City of Alexandria, Virginia

MEMORANDUM

SUBJECT: CONCEPT REVIEW OF 203-205-211 THE STRAND
BAR CASE # 2016-00268

211 STRAND - PROPOSED ROOF PLAN
 203, 205 & 211 Strand Street
 16002

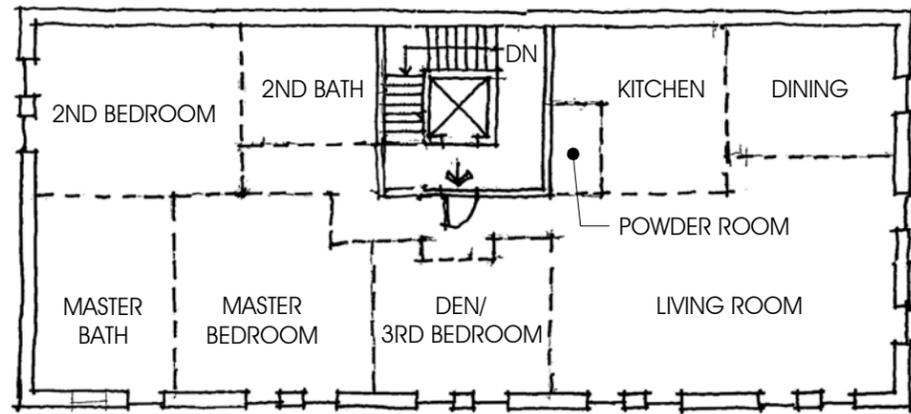
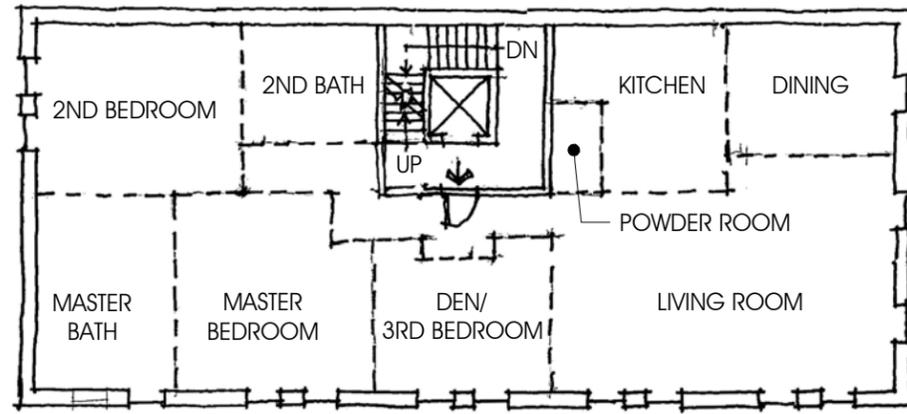
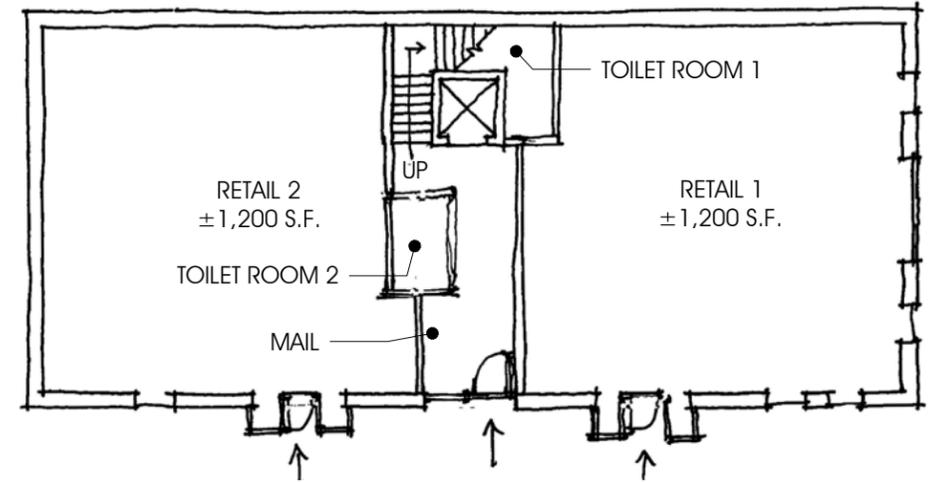
The applicant’s proposal has little information on this building except for notations that a full third floor addition is proposed and a streetscape showing that The Strand elevation would replicate the second story at the third story. The applicant has indicated that they would remove the stucco and restore the fenestration and masonry on the first two floors of the original building. From preliminary research, it appears that this building, which mostly dates from circa 1900 but incorporates some 19th-century stone and brick walls, was also altered throughout the 20th-century. The roof does not appear to date to the earlier period of construction and the fenestration appears significantly altered. Conceptually, staff can support a third story addition of some type but more information needs to be supplied to confirm whether it is appropriate for such an addition to read

simply as an extension of the front elevation or whether the top floor of the east façade should be subtly distinguished as a later addition. It is always challenging to find matching brick when raising a brick building so some variation, or possibly, a setback, may be necessary.

1. Minimize the presence of a garage entrance on South Union Street and enhance the retail facades on both street elevations.
2. Clearly show transition setbacks at thirty feet on the two street-facing elevations.
3. The first floor north elevation presents key opportunities to include historic interpretation or public art and this approach should be integrated early in the design process.
4. Provide more developed schematic plans for the third floor addition at 205 The Strand showing all elevations in context.

211 STRAND - PROPOSED EAST & WEST ELEVATIONS
203, 205 & 211 Strand Street
16002

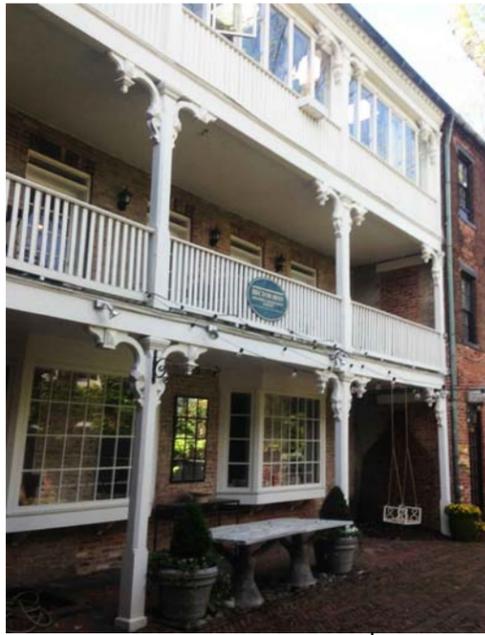
The Strand elevation will be the most visible elevation of this building once the expansion and improvements for Point Lumley Park are completed. Due to its prominent location, it must be proportional and well-designed. The applicant has studied several alternatives for The Strand elevation which appear to be separate but related buildings, using different brick colors and a subtle change in details. The scale of this building-and-addition character can be accommodated because there is more open area in the park and river to the east than there will be on South Union or along the pedestrian alleys of the north and south elevations. The use of pilasters and a pronounced cornice are more high-style than historic photographs suggest for this block, and for that reason, staff prefers the Alternate 1 east elevation that has punched windows and a lighter colored brick on the northern portion of the building. The south elevation retains simple classical pilasters, though there are several examples of higher-style commercial buildings and warehouses such as the Crilley Warehouse on North Lee Street or the Corn Exchange at 100 King Street that provide historic evidence of such an approach along the 19th century waterfront. Staff suggests that the proportions of the southern portion of the building may be more classically appropriate if the white top floor were incorporated into the red brick portion below and pilasters extend to the cornice. As the design is refined, ensuring stylistic compatibility with its context will be essential.

The west elevation quite successfully reads as two separate buildings and the scale and detailing relate well to other historic buildings on South Union Street. Again, Alternate 1 for the west elevation is more refined and complies with the zoning requirement that the street façade set back above 30'. It will be essential to minimize the presence of the garage entrance on this street to the greatest extent possible and to focus attention on the retail storefront.

The proposed design is five stories tall overall with setbacks at the third and fourth floors, depending on the alternative. Staff does not believe that the initially proposed South Union Street elevation complies with the setback requirement, -- a belt course is not enough of a transition above 30' to comply with the standard - - though the massing of the top two floors of Alternate 1 of the west elevation is similar to the proposed east elevation and is set back for approximate 60% of the façade. The BAR may determine that this amount is adequate in this context.

211 STRAND - PROPOSED SOUTH ELEVATION
 203, 205 & 211 Strand Street
 16002

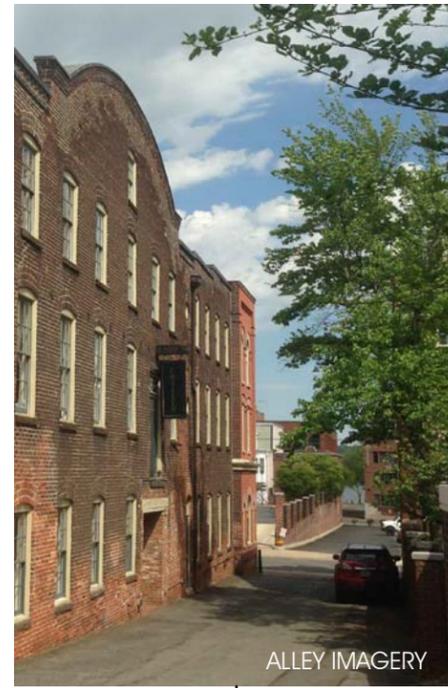
Both the north and south elevations read as three separate “buildings” with a large center building which is broken down by flanking elements with multi-story balconies. Although these elevations read in plan as large and continuous, staff notes that they are adjacent to pedestrian alleys and other buildings and will not be viewed as one elevation. Therefore, the change in “building” typology helps to break down the scale. Staff strongly supports the extensive balconies and suggests that they could be further differentiated from the south to the north elevation. Additionally, the first floor of the north elevation has many blank areas at ground level along the alley. This presents key opportunities to include historic interpretation or public art and this approach should be integrated early in the design process.

STRAND STREET STREETScape

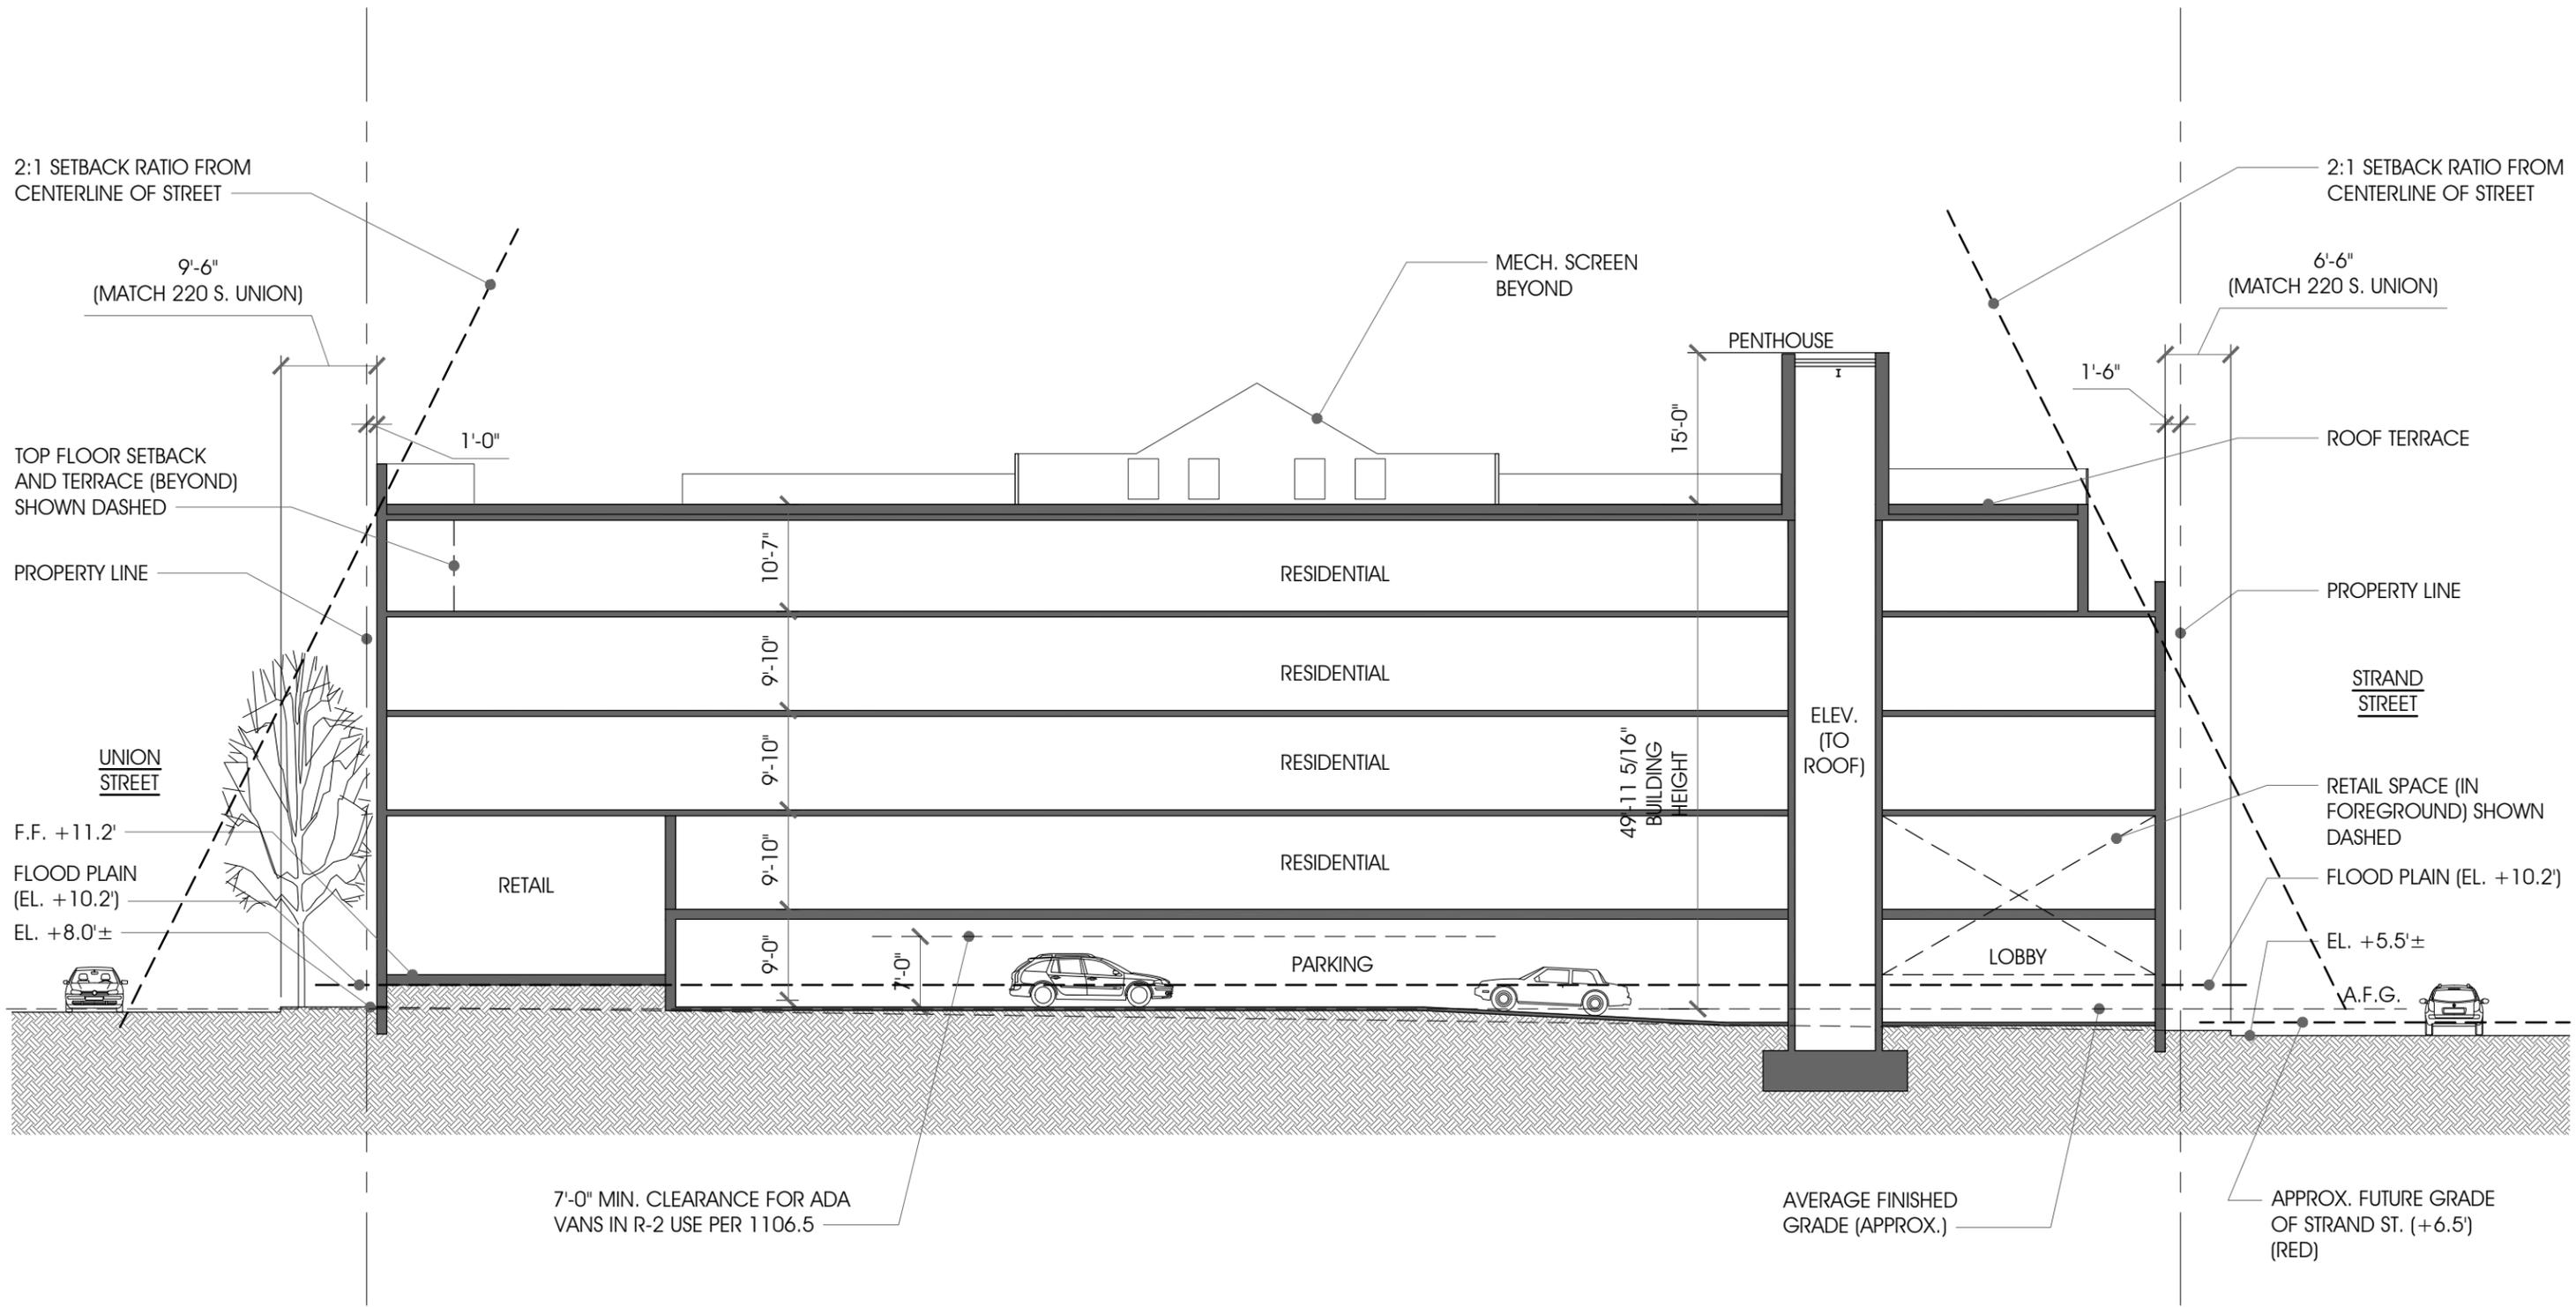
The applicant has provided a streetscape to show the proposed building within the context of existing buildings. The streetscape shows that on Union Street and The Strand, the height of the proposed building will not overwhelm nearby historic buildings. This particular proposal will help
